Product / Process Change Notification (PCN)

PCN #: PCN_FeMLS_20200401

Affected Series: WE-MLS; P/N 74273001

Before Change:

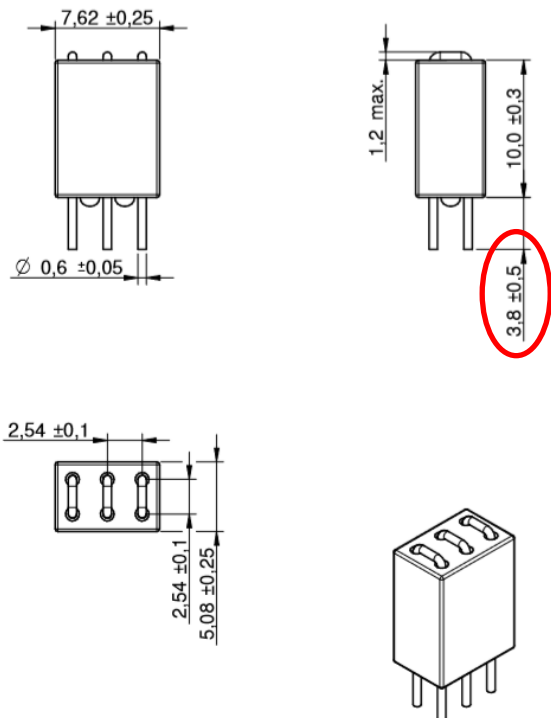
By updating the datasheet the wrong dimension drawing was used. There was no change in any dimension of the part.

After Change:

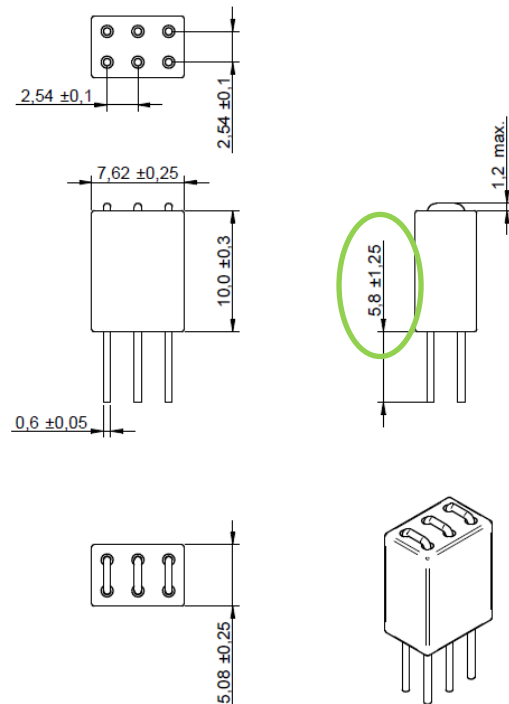
Because of a database mismatch, Würth Elektronik will correct the dimension drawing.
